**AMENDMENTS TO THE DRAWINGS**

### **REMARKS**

Fig. 1

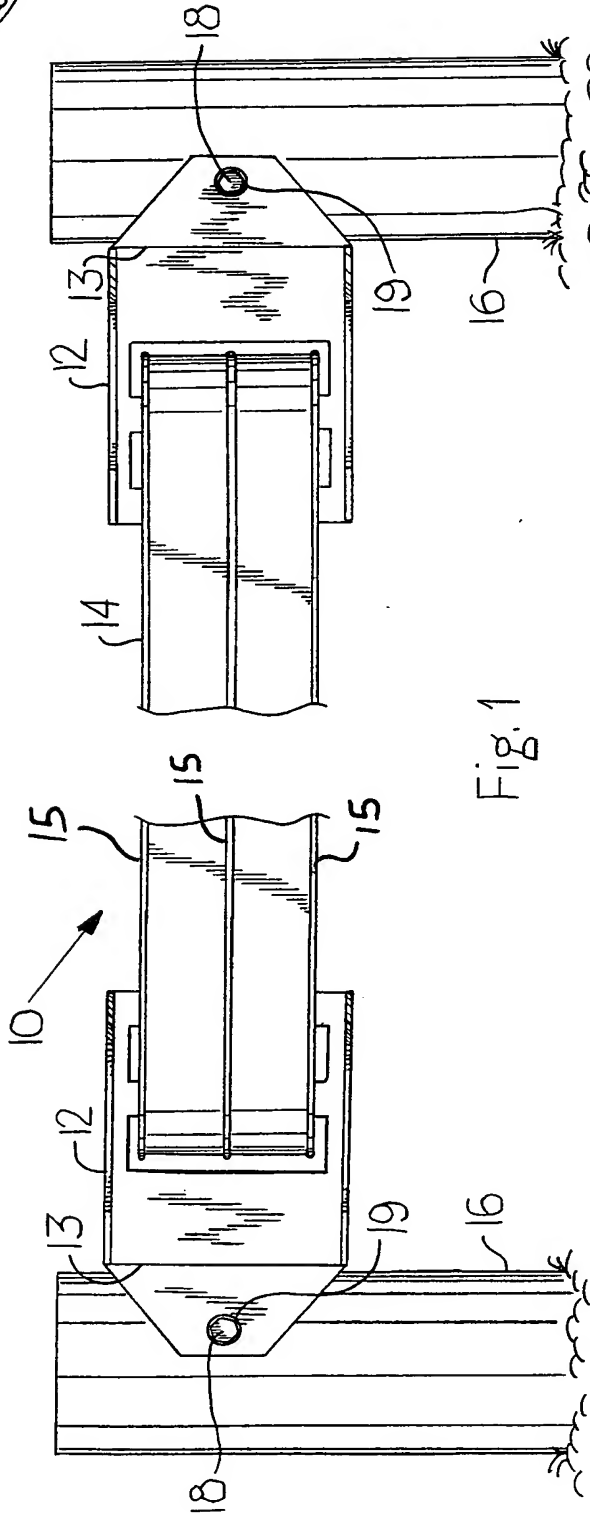
In the specification, paragraph number [0019] has been amended to reference newly added element number '15' in FIGS. 1, 2, and 4 that indicates the metal wires ensheathed in the plastic of the rail. Additionally, the metal wires have been drawn in phantom in FIG. 4. The metal wires have not been drawn in the other figures, as such additions would be duplicative. FIGS. 3-4, 6-7, and 9-14 have been amended to remove the cross-hatching therefrom.

The drawings stand objected to because the cross-hatching is incorrect. Pursuant to 37 C.F.R. §1.84(h) hatching is to be used for sectional views, of which there are none shown in the instant application. As there are only perspective views present, the Applicant has removed the hatchings from the drawings. The Applicant believes that new FIGS. 1, 2, and 4 overcome this particular objection. The drawings also stand objected to for not specifically showing the metal wires referred to in the specification. As indicated in the specification, the metal wires are ensheathed in the plastic portion of the rail. The Applicant believes that new FIGS. 3-4, 6-7, and 9-14 overcome this particular objection. Amendments to FIGS. 1-4, 6-7, and 9-14 are indicated in red in the attached annotated copy of FIGS. 1-4, 6-7, and 9-14. Reconsideration of these objections is respectfully requested.
